**DWR EXHIBIT E**  
Application, File No. 45,570

APPLICATION FOR PERMIT TO APPROPRIATE WATER FOR BENEFICIAL USE  
Filing Fee Must Accompany the Application  
(Please refer to Fee Schedule attached to this application form.)

ASR Project DW-6

Re: Application File Nos.  
45,567 through 45,576  
Wichita ASR Project

**Figure 1. - Equus Beds Groundwater Management District No. 2  
 Aquifer Storage and Recovery Project Map  
 July 13, 2004**

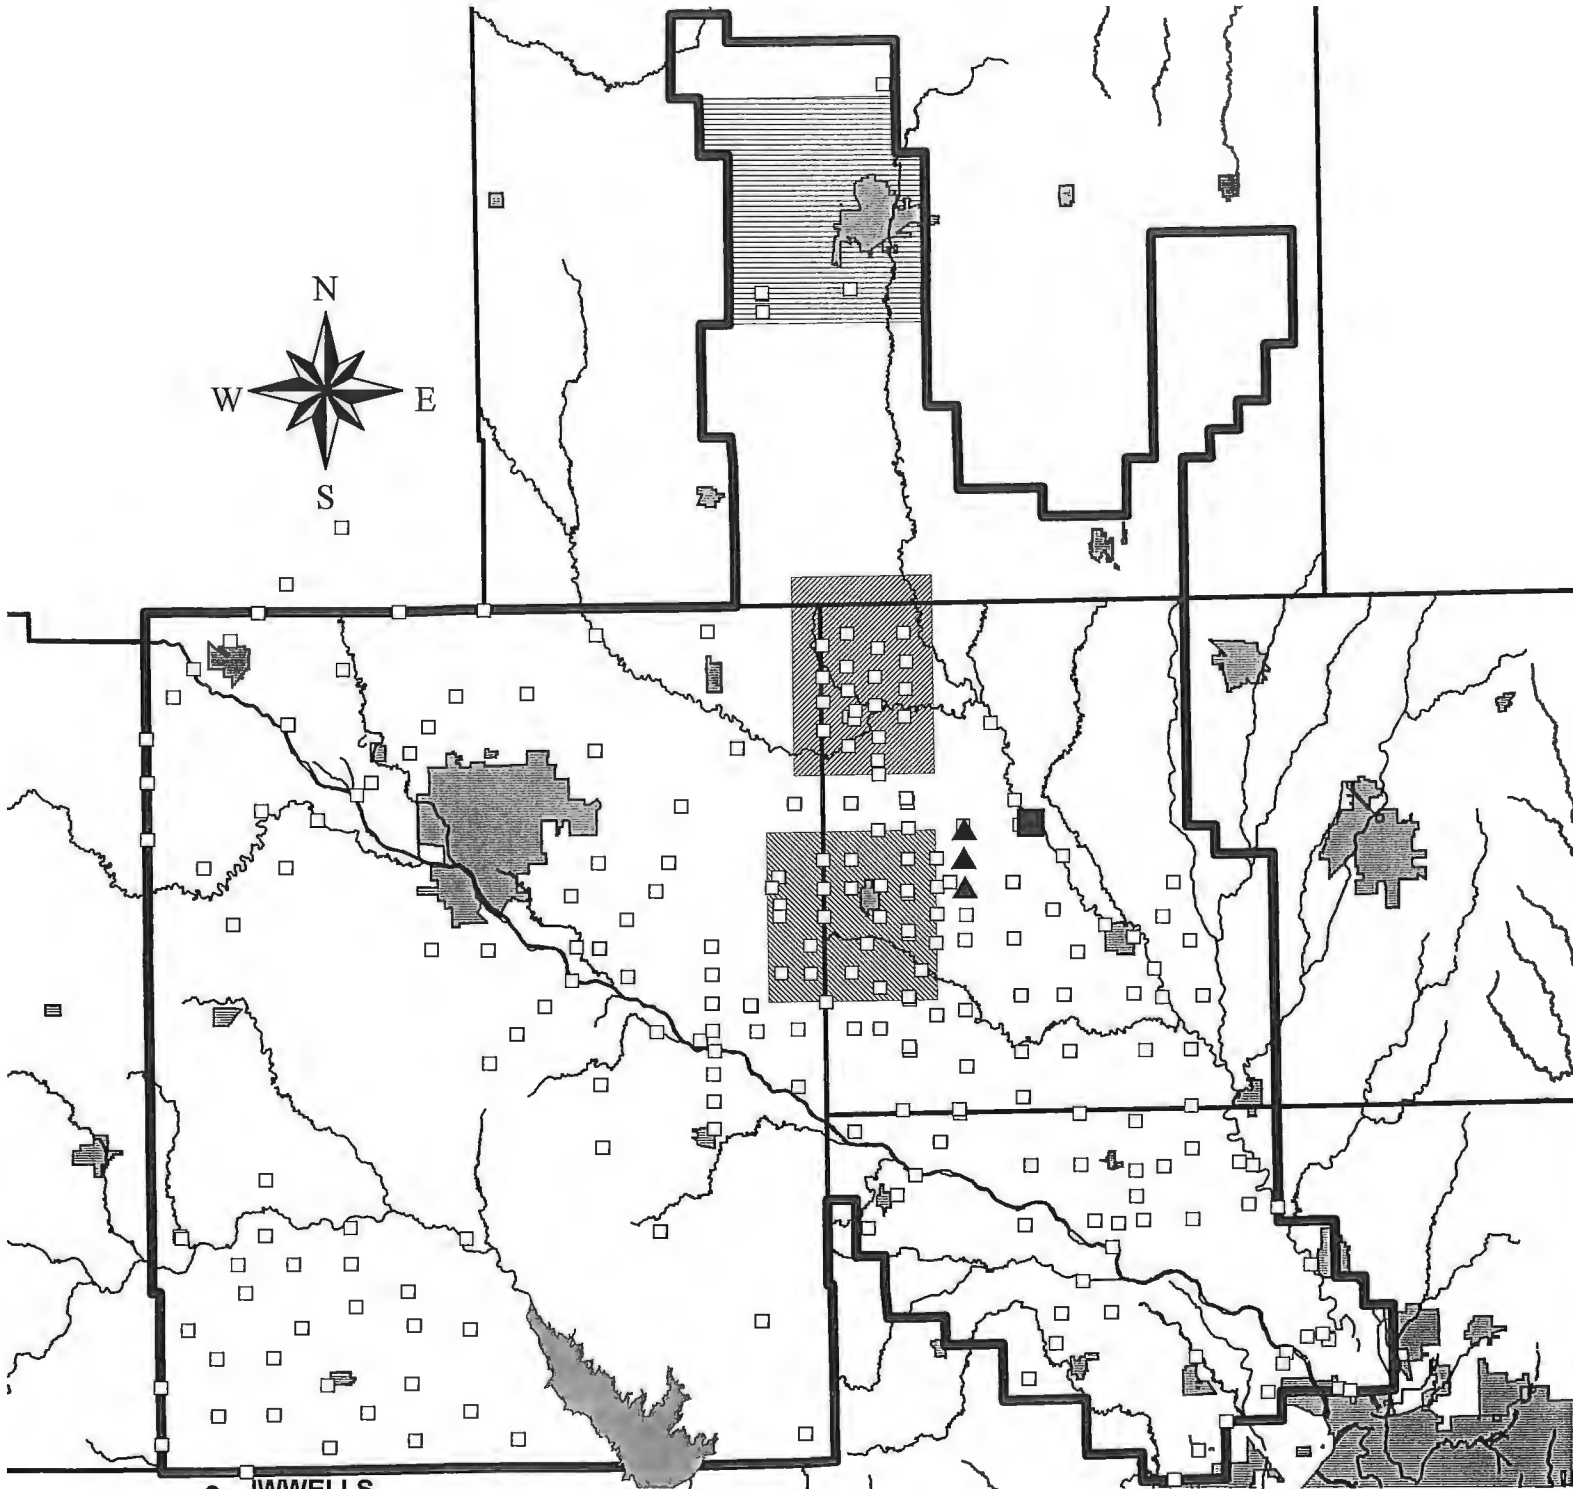
The proposed bank storage well shall be utilized only when river flow exceeds 42 cubic feet per second (cfs) from April through September, and 20 cfs from October through March, as measured at the United States Geological Survey (USGS) gage located at Highway 50 near Halstead (figure 1).

**Figure 2. – Application No. 45570 Site Map - NW 08-23S-2W**  
 Prepared by: Equus Beds Groundwater Management District No. 2 - 06/30/04

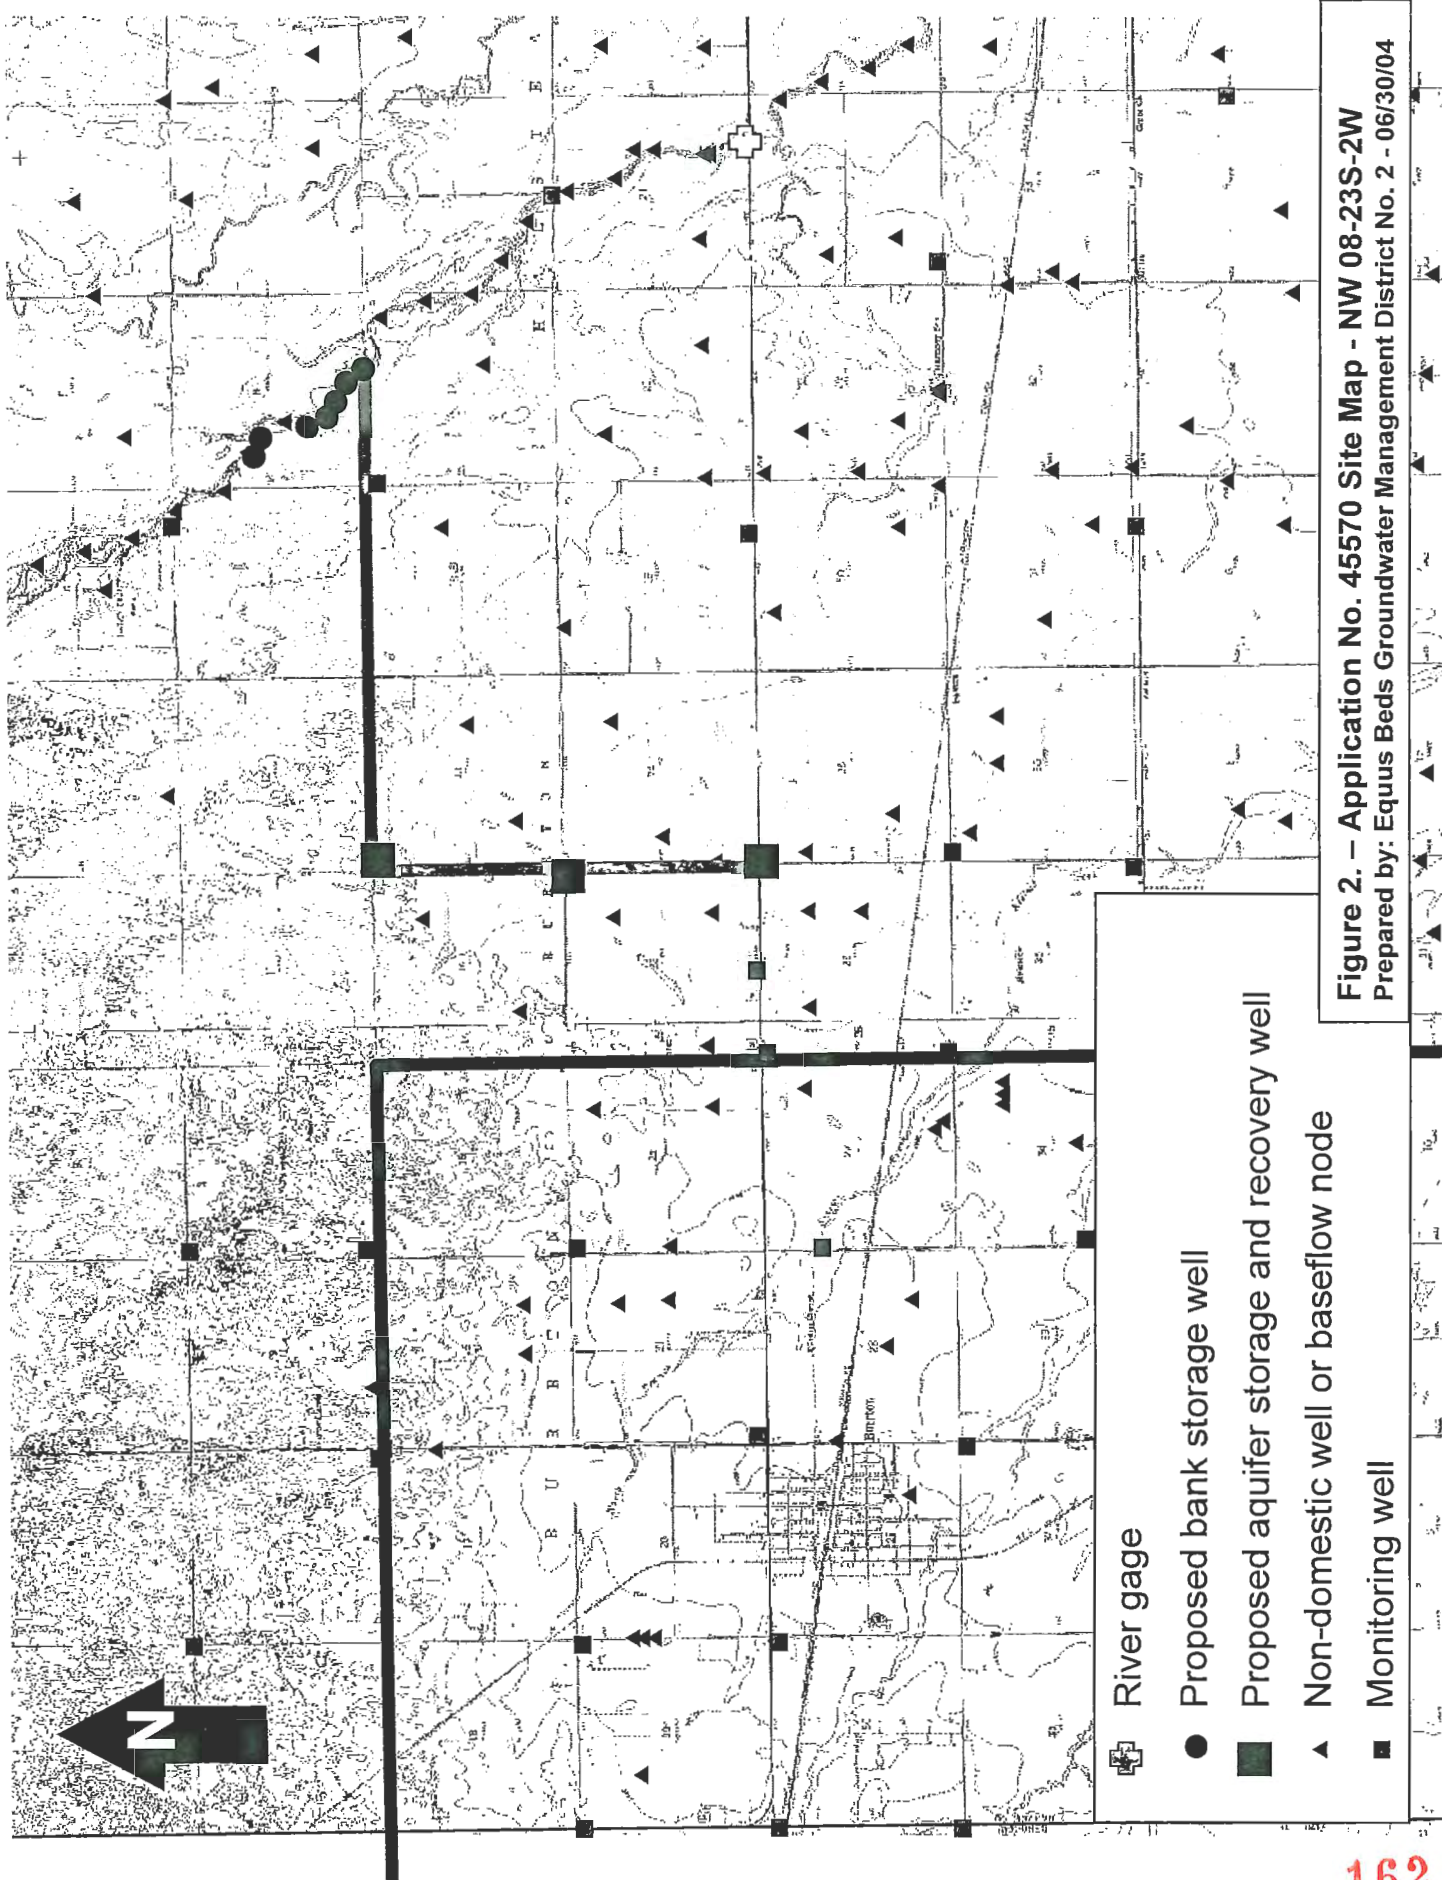
The proposed source water for the applicant's artificial recharge use in the aquifer storage and recovery system, is bank storage water to be diverted from a proposed well located in the SW-SE-NW of Section 8, Township 23 South, Range 2 West (figure 2).

Figure 4. – Application No. 45570 Lithologic Log and Construction Design for Bank Storage Well

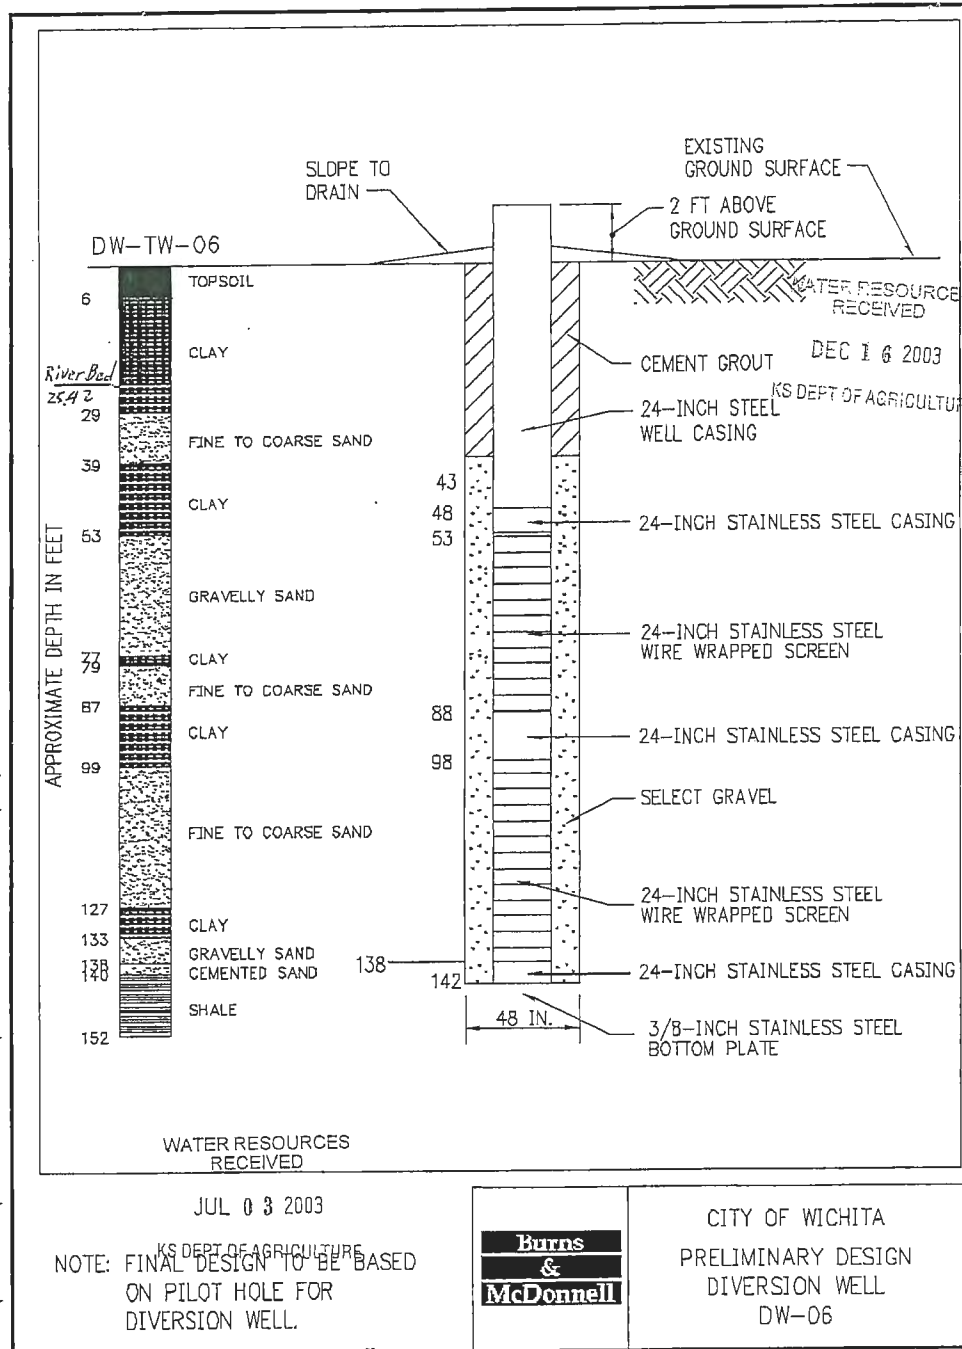
The lithologic log of the proposed well site indicates that the aquifer is comprised of alternating sand and clay layers (figure 4). The proposed well site lithology consists of topsoil 0 to 6 feet bls, clay 6 to 29 feet bls, sand 29 to 39 feet bls, clay 39 to 53 feet bls, sand 53 to 87 feet bls (separated by a thin clay layer), clay 87 to 99 feet bls, sand 99 to 127 feet bls, clay 127 to 133 feet bls, sand 133 to 140 feet bls, and shale beginning at 140 feet bls.

The application's proposed well depth is 138 feet bls (figure 4), with proposed screen intervals from 53 to 88 feet bls and 98 to 138 feet bls. The well is proposed to be screened in the lower portion of the aquifer below both clay units located from 39 to 53 feet bls and 87 to 99 feet bls. The applicant proposes to utilize a 24-inch diameter well casing and screen.

Figure 5.

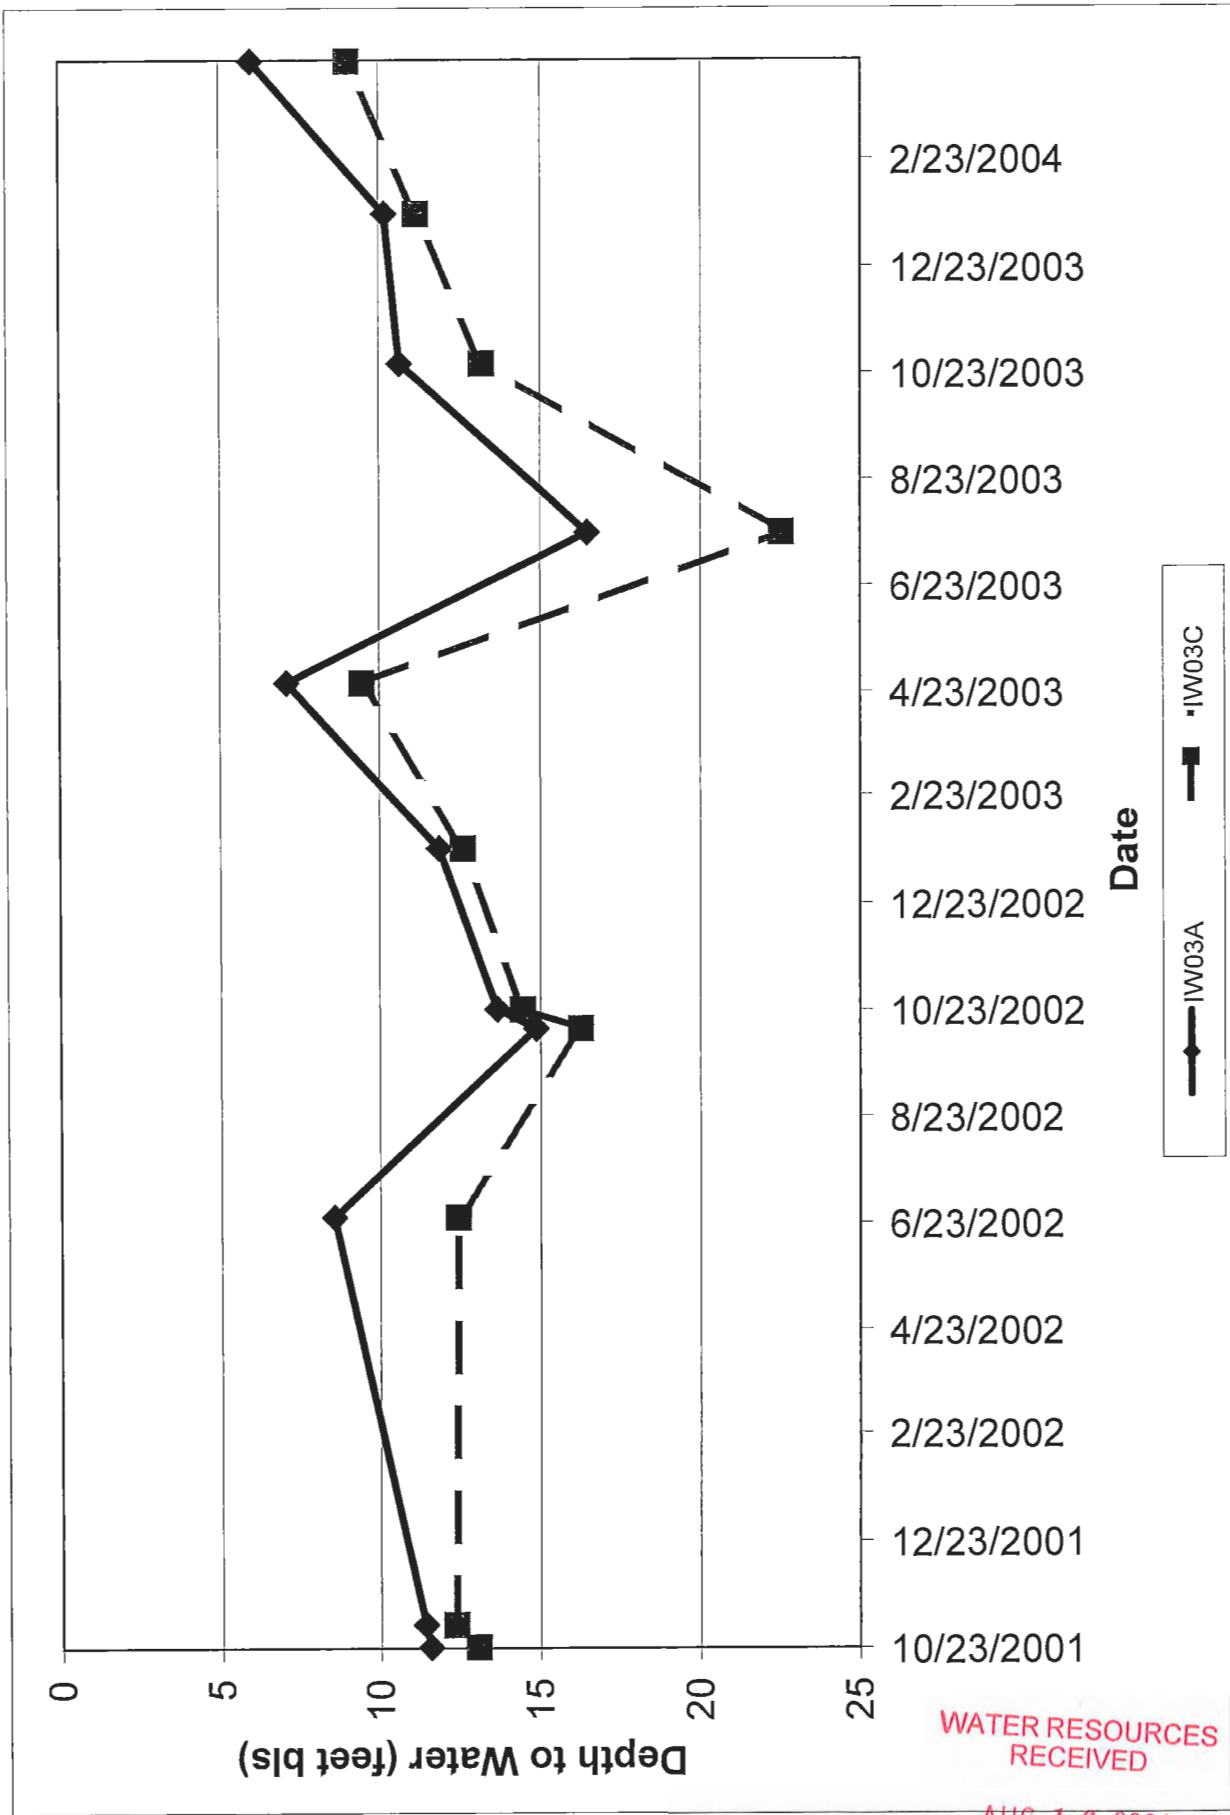
Water level data has been recorded by the District at groundwater monitoring site IW03 located approximately 0.6 mile southwest of the proposed well site (figure 3). Water levels recorded at the site during the period of record from October 2001 to April 2004 (figure 5), ranged from 5.99 to 16.49 feet bls in IW03A (total depth 34 feet), and from 9.03 to 22.53 feet bls in IW03C (total depth 138 feet). The IW03C lithologic log reported that depth to bedrock was 166 feet bls.

IW03 water level data (figure 5) indicated that a head difference ranging from approximately 1 to 6 feet existed between the upper zone (A well) and the lower zone (C well). The water levels in both zones exhibited similar responses to water table fluctuations, indicating a hydraulic connection. The fluctuation responses indicated leakage occurrence from the upper zone to the lower zone. Pumping effects exhibited in the lower zone also affected water levels in the upper zone. The correlation between the data sets indicated that the clay unit separating the two zones is not continuous throughout the area.
